Minutes of an ordinary meeting of the Development Support Special Committee held in the Council Chamber of the Administration Centre, 19 King Edward Street, Ulverstone on Monday, 12 February 2018 commencing at 6.00pm

5/2018 Residential (two lot subdivision and multiple dwellings x five) – proximity to the Utility zone, variation to sunlight and overshadowing for all dwellings and area for waste storage at CT146012/3 Forth Road, Turners Beach – Application No. DA217127

<i>DEVELOPMENT APPLICATION NO.:</i>	DA217127
<i>PROPOSAL:</i>	Residential (two lot subdivision and multiple dwellings x five) – proximity to the Utility zone, variation to sunlight and overshadowing for all dwellings and area for waste storage
<i>APPLICANT:</i>	R & D Rimmelzwaan Pty Ltd
<i>LOCATION:</i>	CT146012/3 Forth Road, Turners Beach
<i>ZONE:</i>	General Residential
<i>PLANNING INSTRUMENT:</i>	<i>Central Coast Interim Planning Scheme 2013</i> (the Scheme)
<i>ADVERTISED:</i>	3 January 2018
<i>REPRESENTATIONS EXPIRY DATE:</i>	17 January 2018

Client:	R & D HOMES
Project:	LOT 3 FORTH ROAD - SUBDIVISION
Title:	SITE PLAN
Drawing No.:	1206-72 G03
Revision:	0

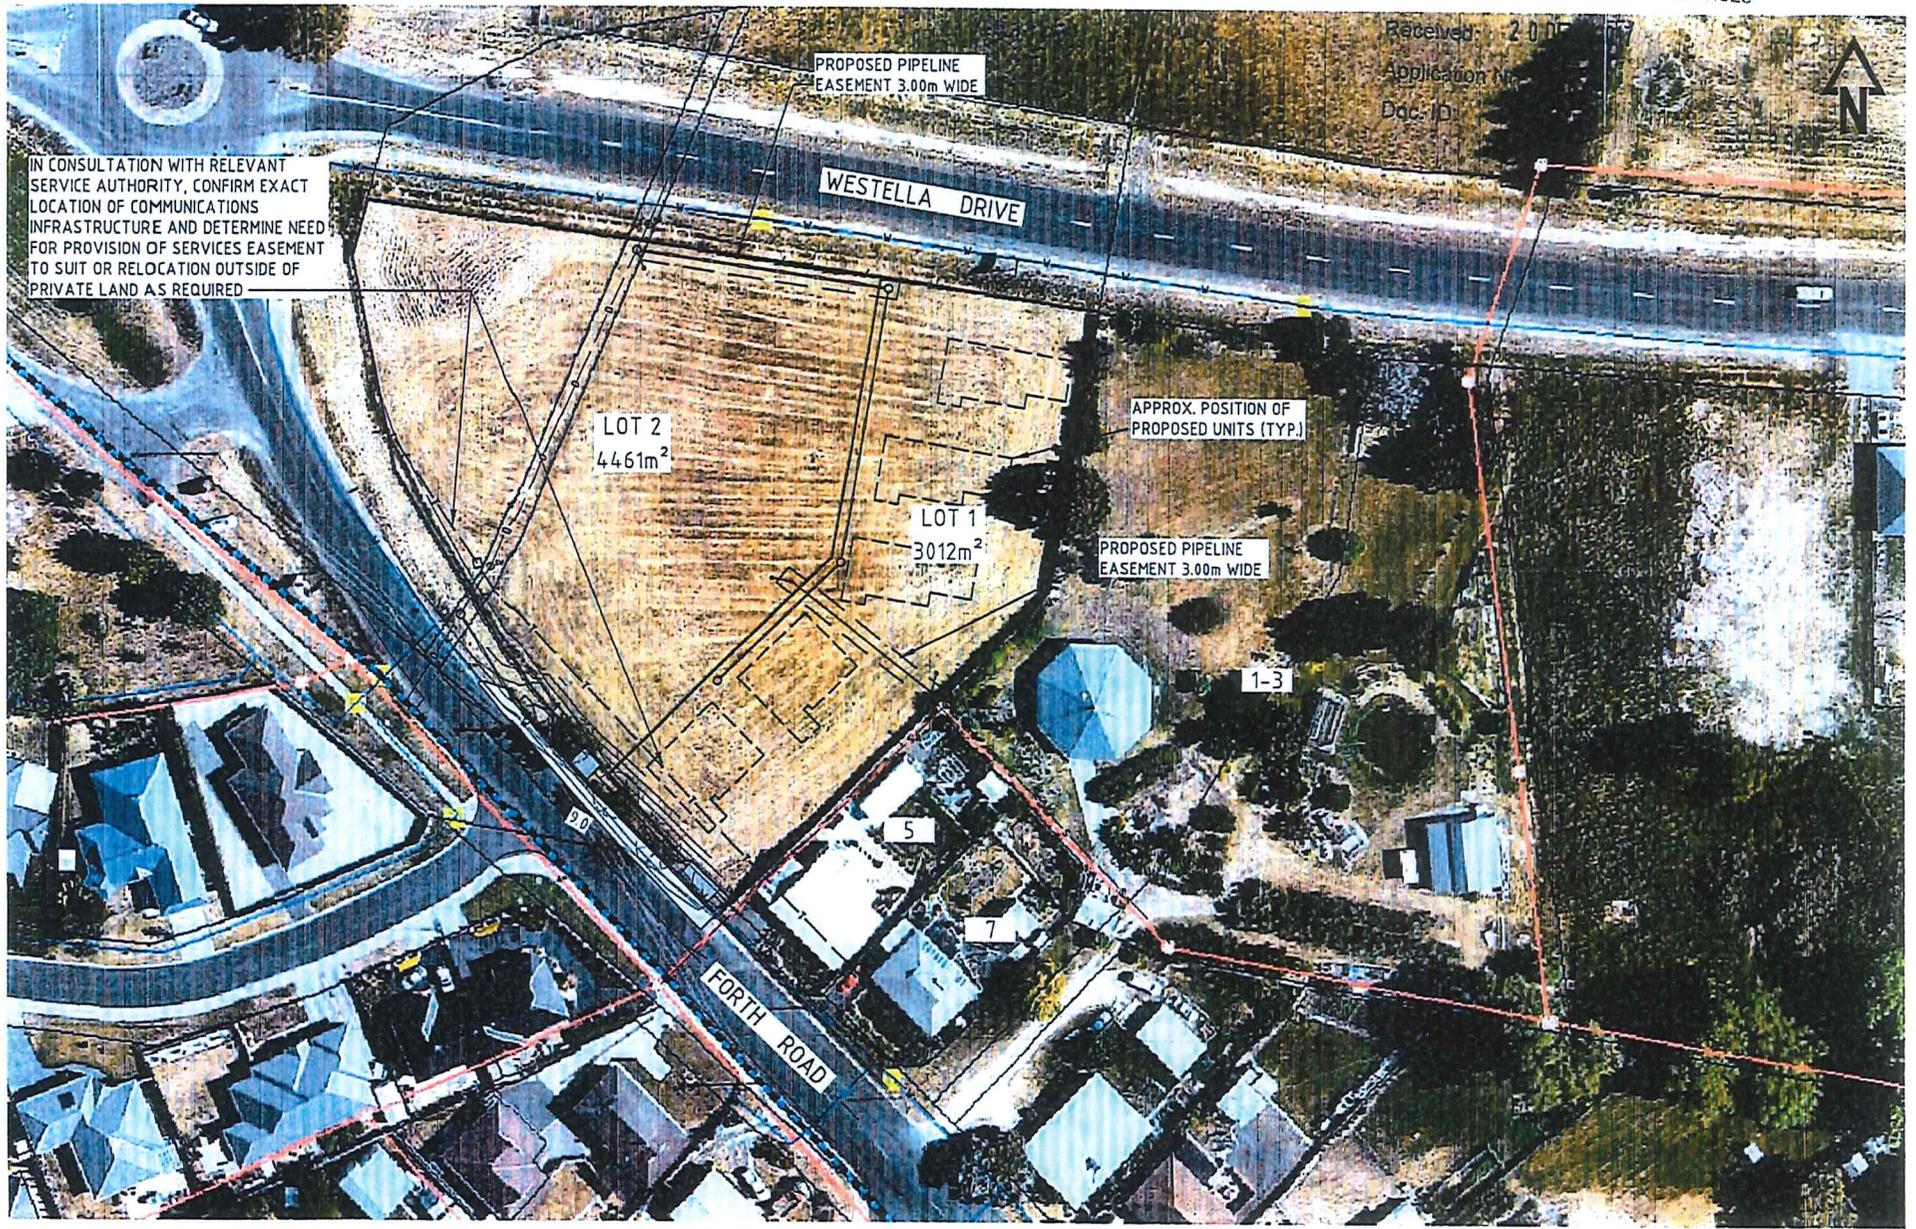
- R2 A concrete vehicular access must be provided to each lot and may be located as shown on the CSE Tasmania Pty Ltd Site Plan, Drawing No. 1206-72 G03 dated 7 and 12 December 2017 (copy enclosed);
